Re: HGY/2023/2584 13 Bedford Road London N22 7AU

I have read the Briefing to Committee for the above application presented to the 4th March 2025 planning sub-committee meeting and watched the recording of the meeting. At the meeting, the applicant's agent referred to documents that are not available on the Haringey Public Register page for this application. I note that new and revised documents were uploaded on 7th, 9th and 11th July 2025 but these still do not include the following. Please can these documents be made available as soon as possible or sought from the applicant:

Fig. 2 view looking north-east from outside nos. 359/357 Alexandra Park Road

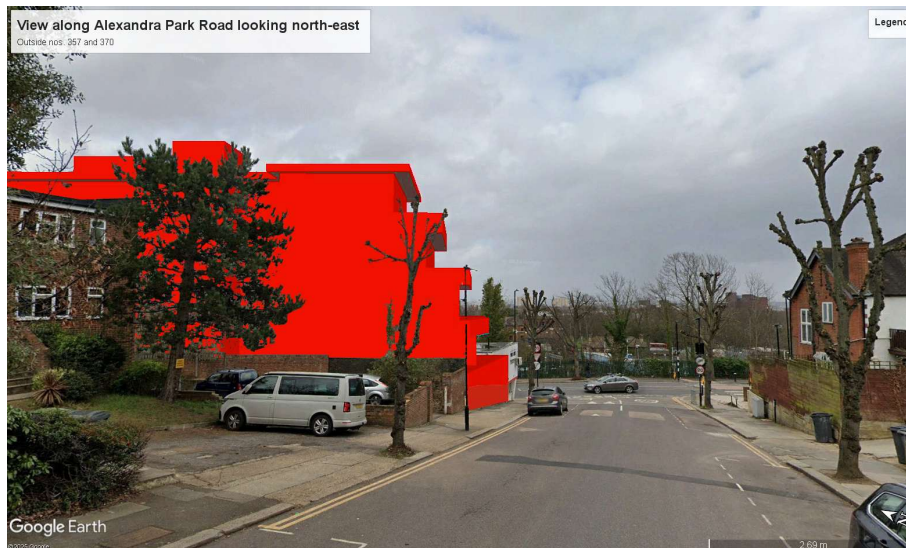
- 2.1. No argument has been made for why the proposals should ignore building lines along Alexandra Park Road and Bedford Road, highlighted in my original objection. Below is an approximate view showing the proposed building would project well beyond other buildings on Alexandra Park Road. See also Fig. 6a, 5b, 5c showing building visibility along Alexandra Park Road and Fig. 1a above showing the proposed building projecting beyond buildings on Bedford Road.

- 4.2. The proposed west elevation does not resolve the interacting issues of security, privacy, fire, daylight/sunlight and appearance and is highly visible since it projects beyond the Alexandra Park Road building line, see fig.2 above and items 5 to 9 below.

Fig. 3a mark-up of applicant's east elevation submitted with this objection

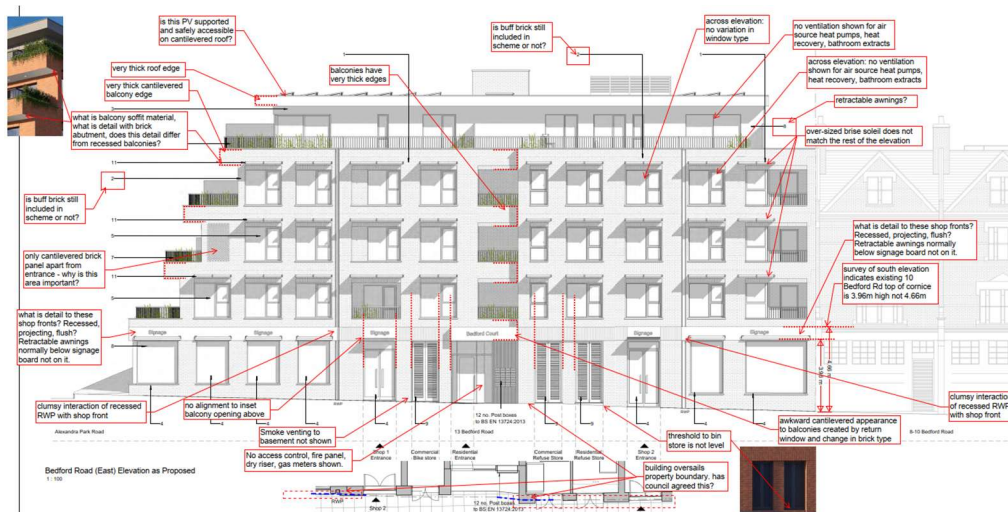
Most items highlighted in my original objection are still unaddressed. See attached mark-up of revised elevations 1544/07 rev E.

- 4.1. Issues with the elevation design, highlighted in my original objection, have not been addressed. Additional items:

- 4.1.1. - No information is provided to show detail and material of shop signage. Its interaction with recessed RWPs appears clumsy.
- 4.1.2. - No material indicated for balcony soffits. Detail of abutment between brickwork and soffits to balconies at south end of proposals differs from recessed balconies in CGIs.

- 4.1.3. - Bin store door threshold to residential store is not level in elevations and CGIs despite Chris Georgiou's email 09 July 2025 12:26.
- 4.1.4. - Some brick is still labelled as buff in key and across various elevations.

- 4.1.5. - The top floor and some balcony elements are labelled as retractable awnings when it appears to be zinc cladding.
- 4.1.6. - The top floor access corridor to the west elevation has been enclosed, giving an awkward cantilever appearance and simplistic aesthetic, looking like building site cabins.

Fig. 3b mark-up of applicant's west elevation submitted with this objection

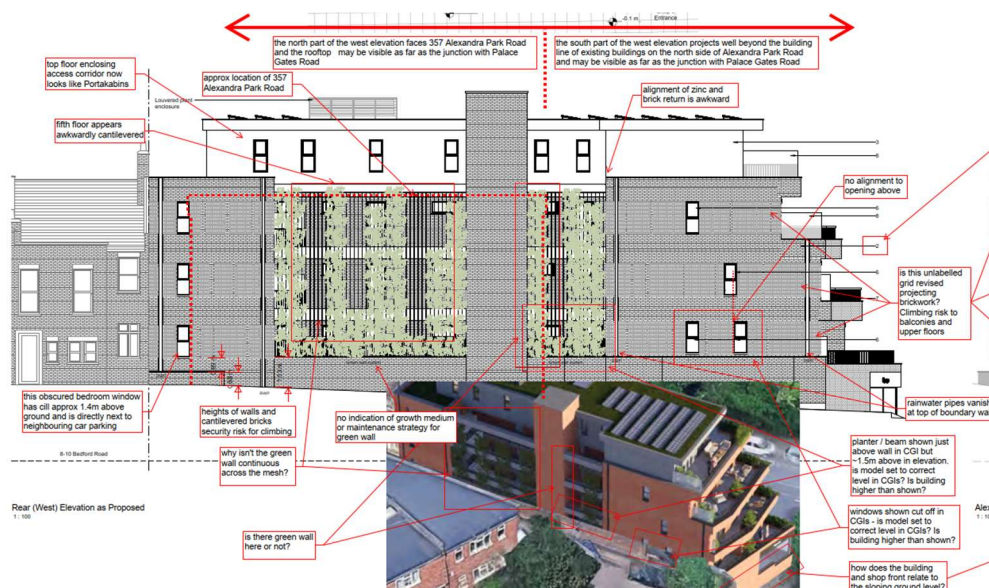
- 4.1.7. - The layout of cantilevered hit-and-miss or honeycomb brickwork to west elevation appears to have changed but this is not labelled on elevations and detail is not explained. The increased extent of cantilevered brickwork also worsens the climbing risk.

Fig. 4 mark-up of applicant's first floor plan noting overlooking and privacy issues

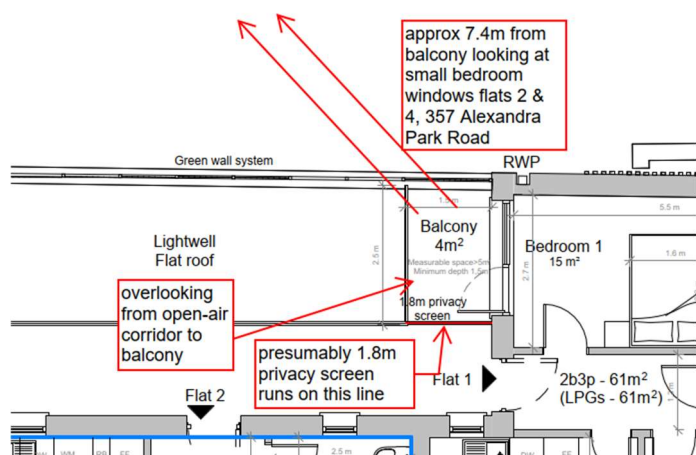
- 9.1. No explanation has been provided of how the maintenance and density of the green wall would be guaranteed to control privacy towards neighbouring buildings. No explanation has been provided as to how balconies immediately adjacent to the open air access corridor would maintain privacy within the development. The marked-up extract of the first floor plan below highlights privacy issues typical at every floor.

Fig. 5 extract of 1544/05E ground floor plan showing building footprint outside site boundary, taking part of public footpath

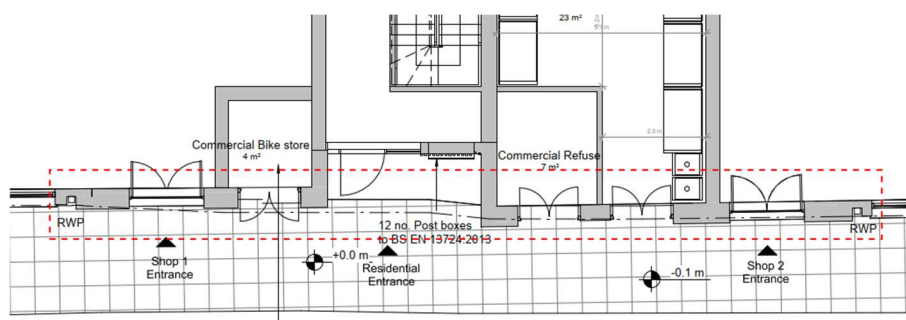
- 22.1. The building oversales the site boundary along the east elevation as shown on floor plans with no evidence that the applicant plans to purchase this land.
